PLAN OF PROPOSED SUBDIVISION  
 OF LOT 6 SEC H DP 27358  
 AT CORNER OF QUAY RD & SIR HENRY CRES  
 CALLALA BEACH FOR MR & MRS SLATER

PROPOSED BUILDING CONTROLS RELATING TO  
 SUBDIVISION OF LOT 6 SEC H DP 27358 AT  
 CORNER OF QUAY RD & SIR HENRY CRES  
 CALLALA BEACH FOR MR & MRS SLATER

Our Ref: 25058LDC

DEVELOPMENT APPLICATION FOR SUBDIVISION AT SIR HENRY CR CALLALA BEACH FOR SLATER

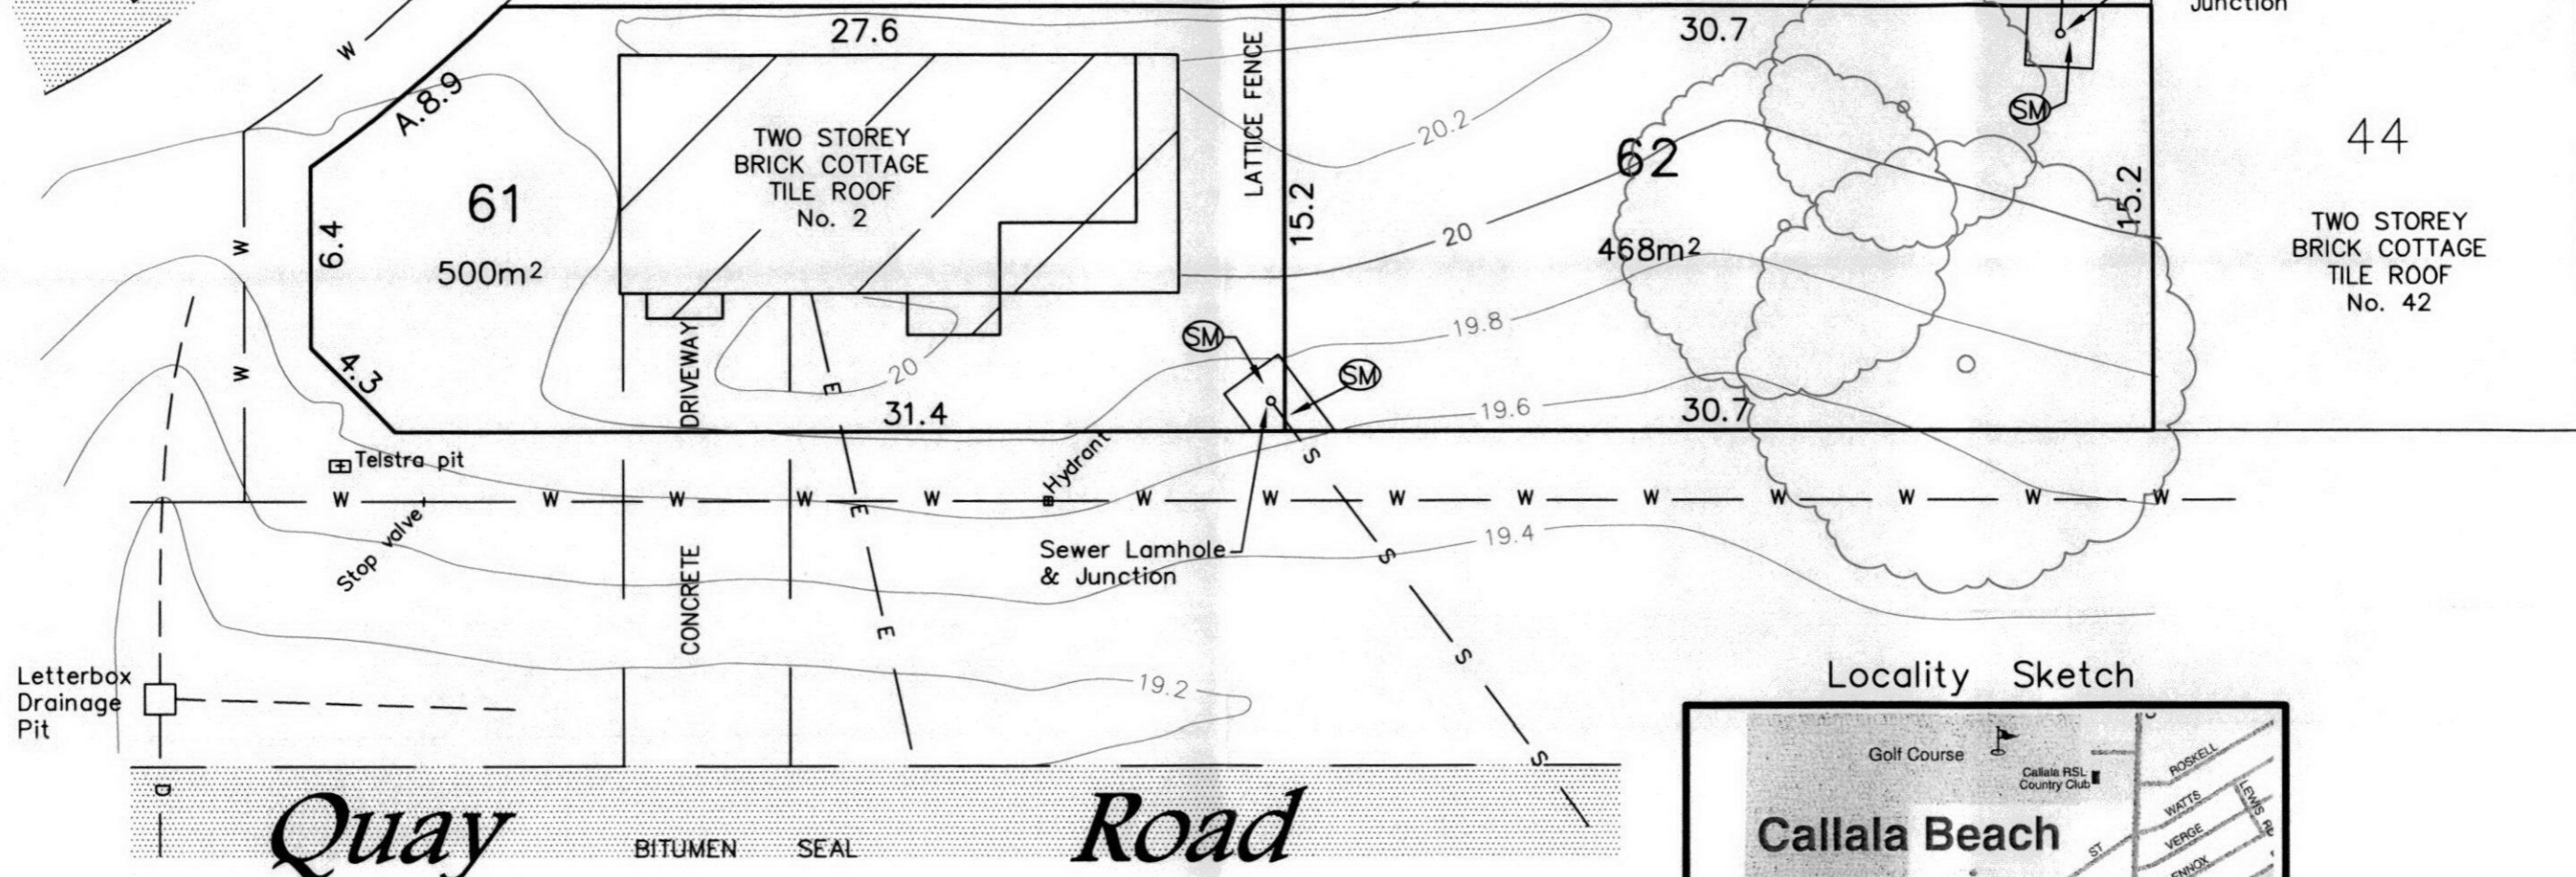
- *Non-compliance with minimum lot area*

- *Proposed lot depth of 15.2m, non compliance with DCP 100*

There is no minimum lot area contained within DCP 100. The acceptable solution of 500m<sup>2</sup> is simply an acceptable solution. *Acceptable solutions should not be interpreted as an alternative prescriptive form of regulation. They are examples of what is considered acceptable, but they do not preclude other solutions which achieve the desired performance.* A performance based assessment of the proposal has been completed above.

There is no minimum lot depth contained within DCP 100. The acceptable solution of 30m square width is simply an acceptable solution. *Acceptable solutions should not be interpreted as an alternative prescriptive form of regulation. They are examples of what is considered acceptable, but they do not preclude other solutions which achieve the desired performance.* A performance based assessment of the proposal has been completed above.

REF. NO. **25058-02**

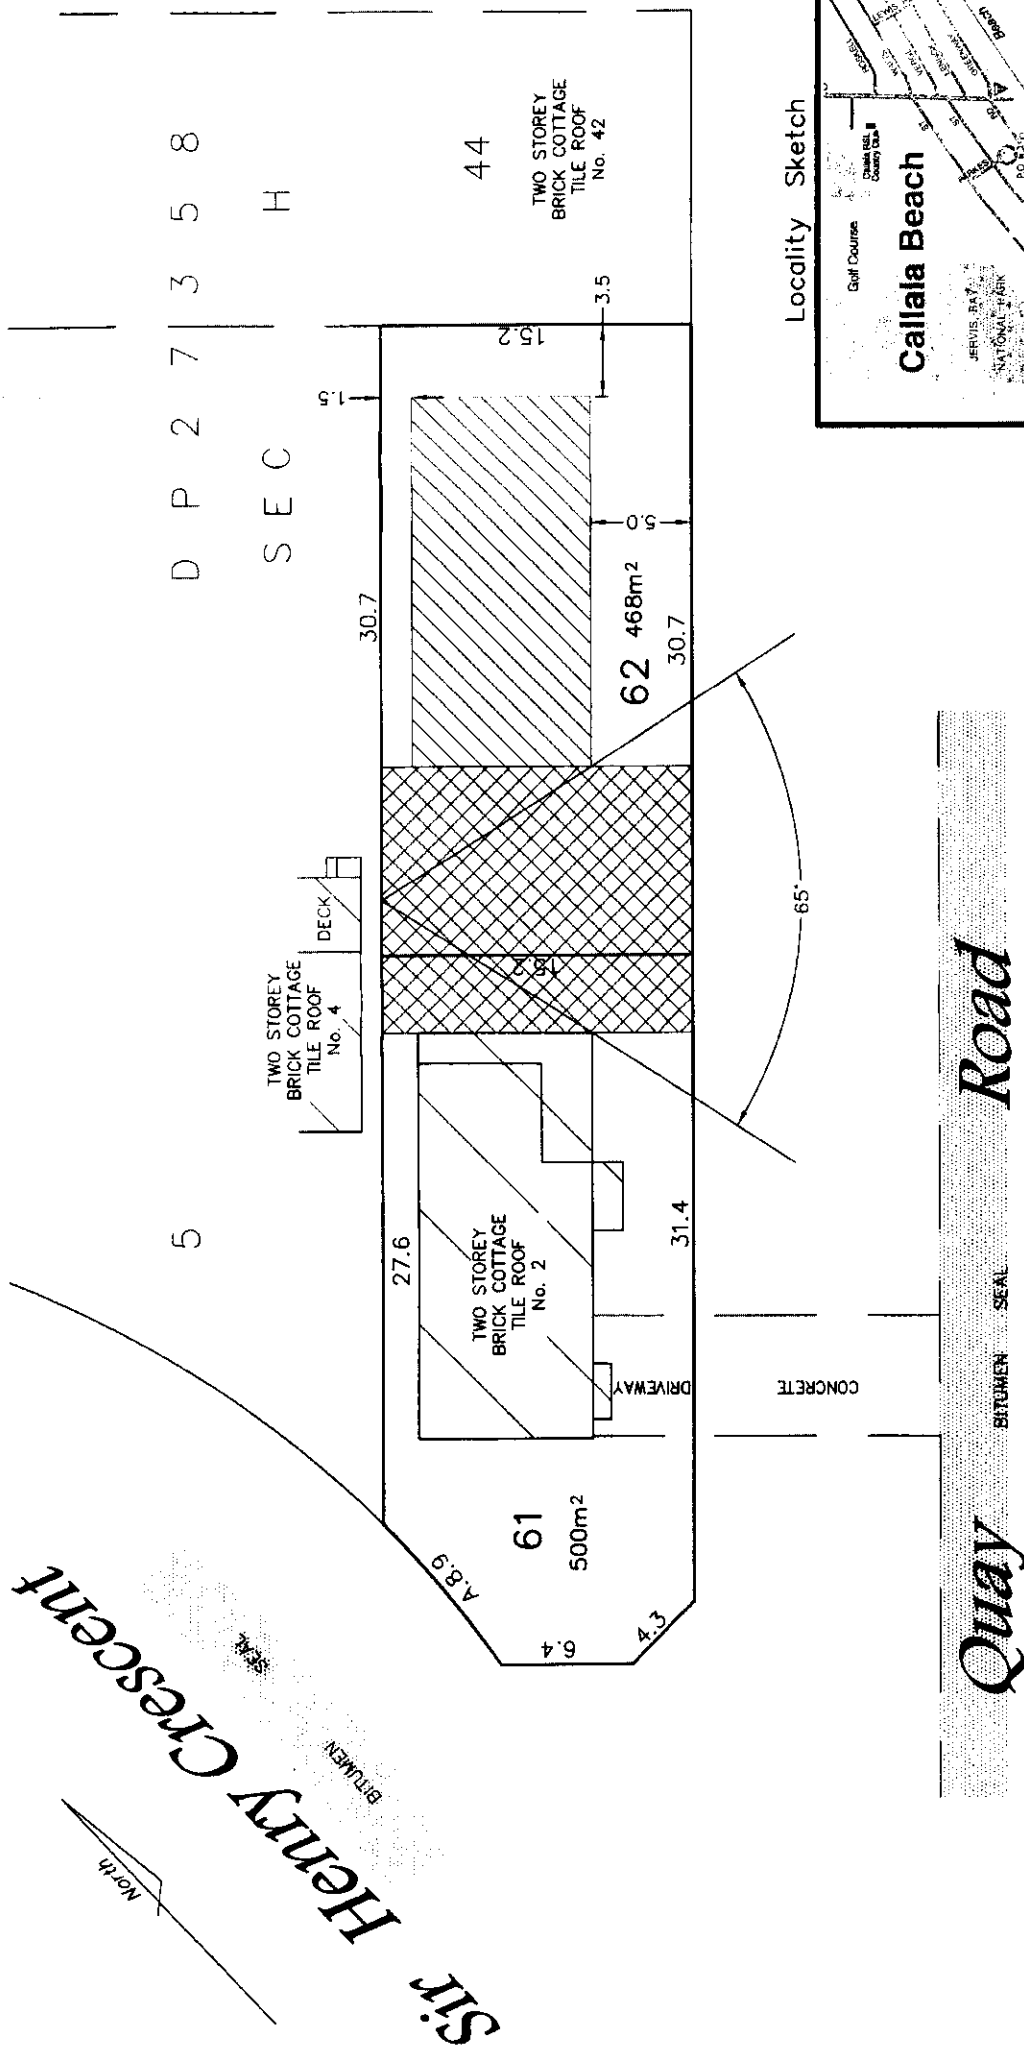
- *Due to likely positioning of new dwelling – adverse impact due to loss of privacy and additional noise*

- *Due to likely positioning of new dwelling – overshadowing and loss of air from prominent NE breezes*

Proposed Lot 62 will be created as a vacant lot with an area of 468m<sup>2</sup>. It has been demonstrated on the submitted sketch plan (ref: 25058-02) that a reasonably sized dwelling with a floor area of over 200m<sup>2</sup> with appropriate side, rear and front setbacks can be accommodated on site without complication. The amount of open space available on site with taking into consideration the footprint of the building envelope proposed would be about 315m<sup>2</sup>. The foot print of a future dwelling within the nominated envelope we have proposed would only cover 33% of the site.

With respect to maintaining views, it is proposed to limit the erection of future buildings on the newly created lot to those areas shown on the sketch attached to this letter. As can be seen from a review of this sketch it is proposed to provide adjoining land owners with a view corridor of about 13m wide providing a approx 65° views though the site. This is considered to be extremely generous given that the properties that will benefit from the proposed viewing corridor are located such that it may be considered unreasonable for occupants of such properties to expect a view to be maintained 2 rows of houses removed from the water front. It must be recognised that any dwelling constructed on the eastern side of Quay Road up to the maximum height allowable under Council's DCP 62 would most certainly erode any notable view from any property located on the opposite side of the street including the subject land.

Proposed lot 62 contains sufficient space for the construction of a dwelling house. It has been demonstrated on the submitted sketch plan (ref: 25058-02) that a reasonably sized dwelling with a floor area of over 200m<sup>2</sup> with appropriate side, rear and front setbacks can be accommodated on site without complication. The amount of open space available on site taking into consideration the footprint of the building envelope proposed would be about 315m<sup>2</sup>. The foot print of a future dwelling within the nominated envelope we have proposed would only cover 33% of the site.

The viewing corridor will assist in maintaining existing breezes. Any new dwelling on the new lot will cast a shadow in the opposite direction to any adjoining houses. Shadows will be cast over Quay Road.
